Interactive comment on “Flooding in the Mekong Delta: Impact of dyke systems on downstream hydrodynamics” by Vo Quoc Thanh et al.

Vo Quoc Thanh et al.

Received and published: 18 June 2019

Fig. 1.

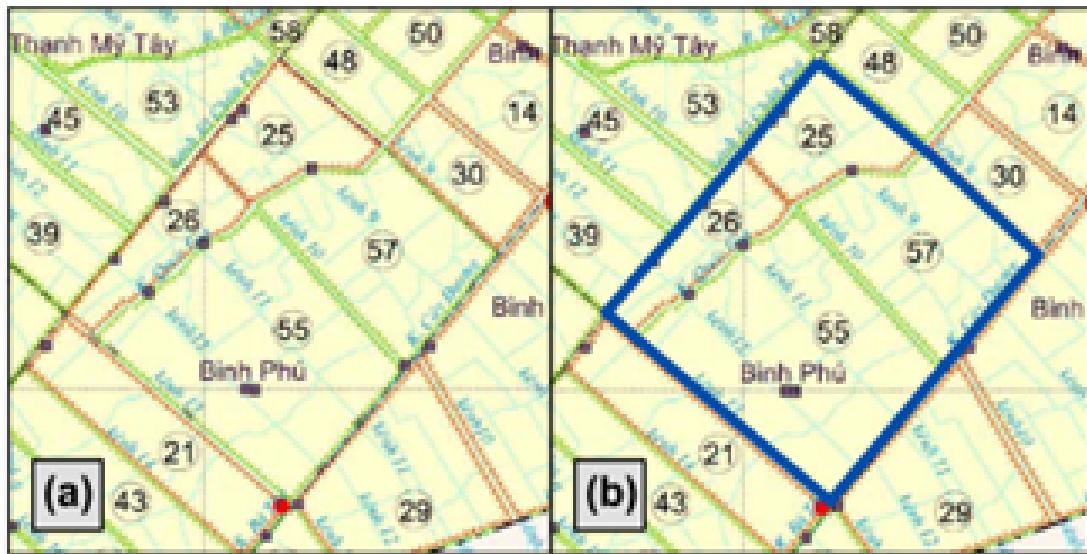
Dear Referee #1, Thank you so much for taking time to review and comment. We will consider your comments on the manuscript to revising the manuscript. The following section is our responses to your comments. Authors' response: The number of the annual flood volume at Kraie is estimated by about 416 km³. The reviewer#1 suggests the flood volume of 475 km³ is an estimate of the whole Mekong River. 1. what is the problem of dyke ring with mixed heights (obliviously the lowest point determines the level of protection) 2. Why it happens in this methodology (or what exactly happens: mixed height dyke rings misidentified as single height in the model?) 3. What is the relationship to ignoring small canals? Authors' response: The lowest elevation of a dyke ring determines the level. The canal system in the Vietnamese Mekong Delta

is dense, but the model considered the primary and secondary canals. The tertiary canals was excluded. Figure 1 presents an example of high dykes and low dykes. Unfortunately, the canal between low dykes and high dykes was excluded. The areas protected by high dyke is smaller than those protected by low dykes in the blue polygon (Figure 1b), so we assume that the blue polygon is defined as a low dyke in modelling.

Figure 1. An example of high dykes and low dykes; (a) high dykes in orange and low dykes in green; (b) the blue line presents a low dykes in modelling. (After Triet et al. 2017) is the kurtosis discussion necessary? This is useful if you do statistics of hundreds of hydrographs, but in this case we can clearly see that slipstream's are flatter by looking at the hydrographs. Authors' response: Although the different shapes of hydrographs are recognised by looking, the kurtosis helps to determine the differences. In this study's context, there is little value in doing a tidal harmonics analysis in my opinion. What you wanted to show is the high dyke development will affect the tidal impact on the river level in inland locations, while dykes do not affect it much in the coastal locations, as far as I could understand. A single graph showing the change in tidal range under different scenarios in various stations would show this adequately. Authors' response: As we responded to the comment 4, the results of tidal harmonic analysis help to understand tidal propagation which is indicated by the diurnal constituents (K1, O1, P1 and Q1) and the semidiurnal constituents (M2, K2, N2, and S2). In my opinion, using these indexes to present tidal variation is better than tidal ranges at which water levels are influenced by the annual floods. QLPH - is it a region or the project name? Please mark this area/infrastructure on a map (not at a new figure but in figure 4 or 1) and refer to it here. Authors' response: QLPH is a project which was constructed for water management in the coastal Mekong Delta (Hoanh et al. 2012). It is on the Figure 1.
